1.14 DOSE EQUIVALENT I-131

ATTACHMENT A
SAFETY EVALUATION/
SIGNIFICANT HAZARDS EVALUATION

FIGURE 3.1-1 .

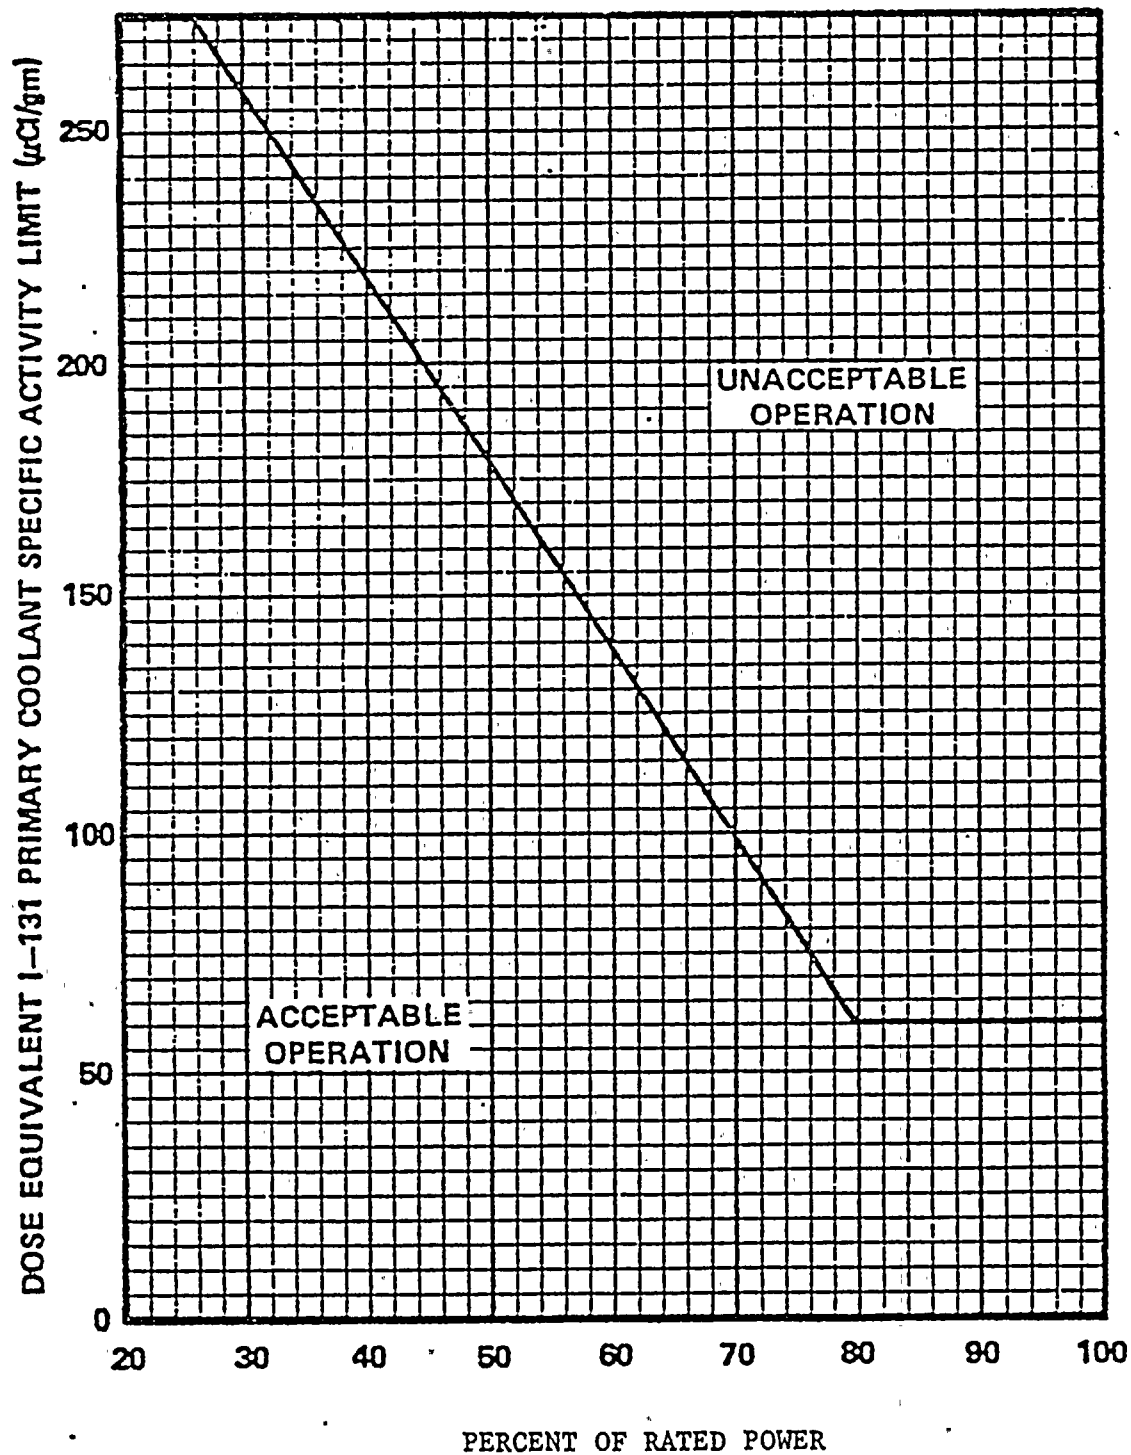
- 1. When the reactor is critical or average reactor coolant temperature is greater than 500 F:
 - a. With the specific activity of the primary coolant greater than 1.0 microcurie per gram DOSE EQUIVALENT I-131 but within the allowable limit (below and to the left of the line) shown on Figure 3.1-1, operation may continue for up to 48 hours provided that the cumulative operating time under these circumstances does not exceed 800 hours in any consecutive 12 month period. With the total cumulative operating time at a primary coolant specific activity greater than 1.0 microcurie per gram DOSE EQUIVALENT I-131 exceeding 500 hours in

- b. With the specific activity of the primary coolant greater than 1.0 microcurie per gram DOSE EQUIVALENT I-131 for more than 48 hours during one continuous time interval or exceeding the limit line shown on Figure 3.1-1, be in a SHUTDOWN condition with average reactor coolant temperature less than 500 F within 6 hours.
- c. With the specific activity of the primary coolant greater than $100/\bar{E}$ microcuries per gram, be in a SHUTDOWN condition with average reactor coolant temperature less than 500 F within 6 hours.

The statement permitting POWER OPERATION to continue for limited time periods with the primary coolant's specific activity greater than 1.0 microcuries/gram DOSE EQUIVALENT I-131, but within the allowable limit shown on Figure 3.1-1, accommodates possible iodine spiking phenomenon which may occur following changes in THERMAL POWER. Operation with specific activity levels exceeding 1.0 microcuries/gram DOSE EQUIVALENT I-131 but within the limits shown on Figure 3.1-1 must be restricted to no more than 800 hours per year (approximately 10 percent of the unit's yearly operating time) since the activity levels allowed by Figure 3.1-1 increase the 2 hour thyroid dose at the site boundary by a factor of up to 20 following a postulated steam generator tube rupture. The reporting of cumulative operating time over 500 hours in any 6 month consecutive period with greater than 1.0 microcuries/gram DOSE EQUIVALENT I-131 will allow sufficient time for Commission evaluation of the circumstances prior to reaching the 800-hour limit.
